**To:** McClellanville Architectural Review Board  
**From:** Eddie Bernard, RLA, Planner  
**Date:** September 16, 2025  
**Re:** Design Revisions during construction, 316 Dupre Road, TMS 764-15-00-015

The Meeks have submitted redlined plans indicating changes made to the previously approved construction drawings for the elevating and additions to the existing single-family residential structure that was completed on the above referenced property. Per Section 12.4.9(c) of the Town's zoning ordinance, "*Subsequent to approval of a Certificate of Appropriateness, any modification in design details must be reconsidered by the Board ....*". Failure to do so is a violation of the Ordinance.

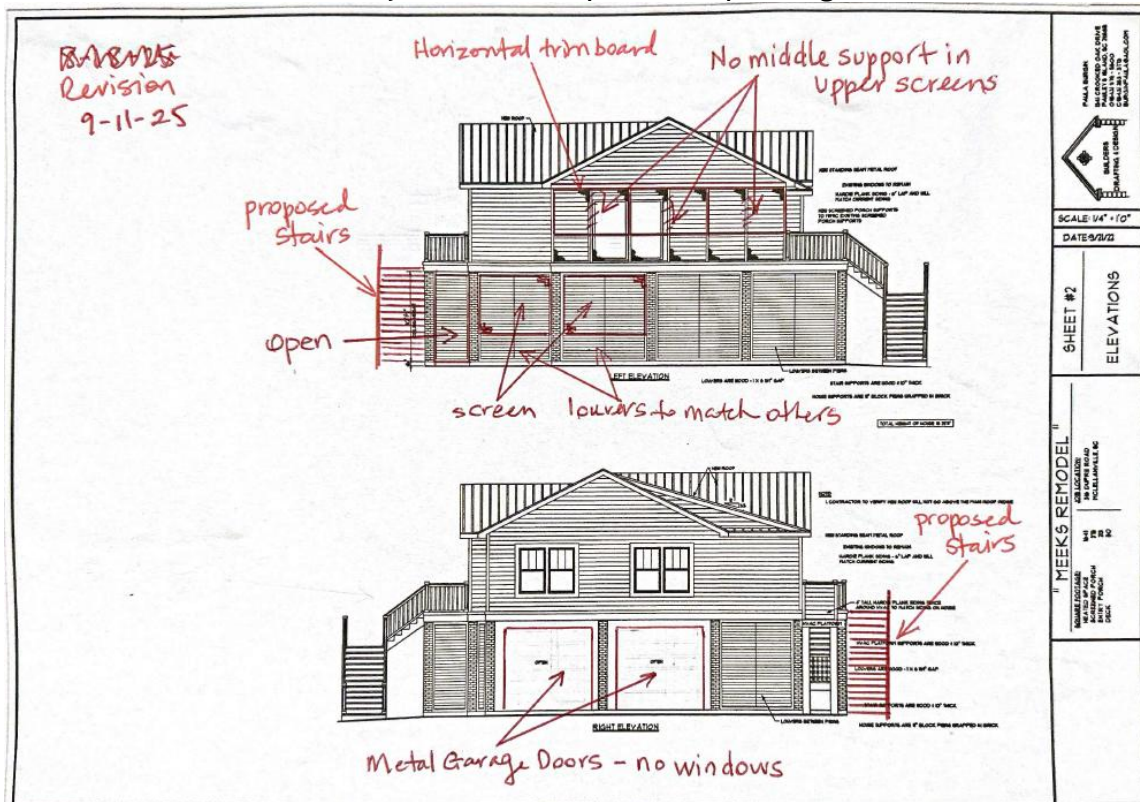
**Screen porch:** The original screen porch had dividing elements which broke up the expanses of screen that have now been removed. The guidelines have several mentions of screen porches. 'Front porches maybe screened when the work does not destroy original or historic materials and forms, including columns, balustrades, railings and decorative detailing....New screen

doors on newly screened porches should be plain so the emphasis remains on the original porch details and should be construction of wood.' The former framing detail that further broke up the screen porch expanses has partially been omitted and is currently only present on the lower 1/3 below the horizontal railing member.

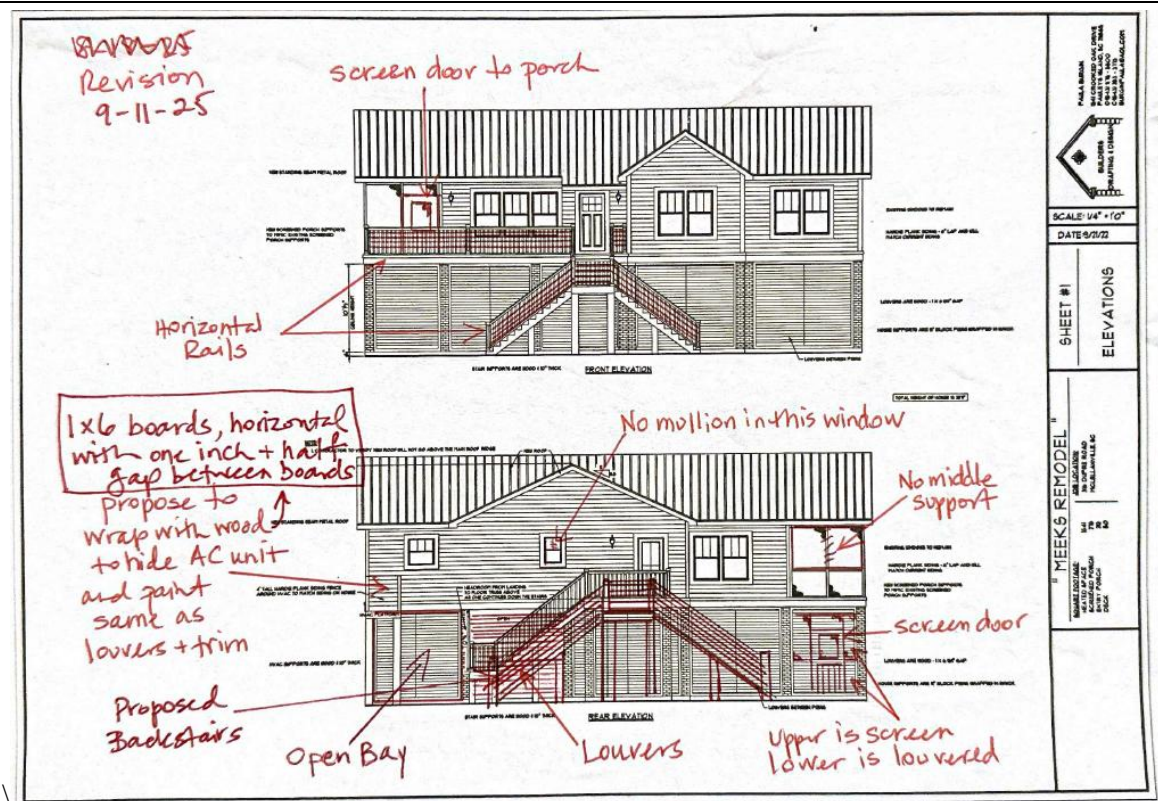
**Windows:** The existing windows to the house have muntins in the upper sash to provide decorative elements. A rear window has been installed without this detail. The guidelines indicate that 'Where replacement windows are necessary they should match the material and configuration of the original windows. Simulated divided-lite windows and windows constructed of material such as aluminum and vinyl are not acceptable on contributing buildings. True divided lights and muntins with an exterior profile comparable to contributing buildings of a similar architectural style are acceptable in new construction or noncontributing structures.'
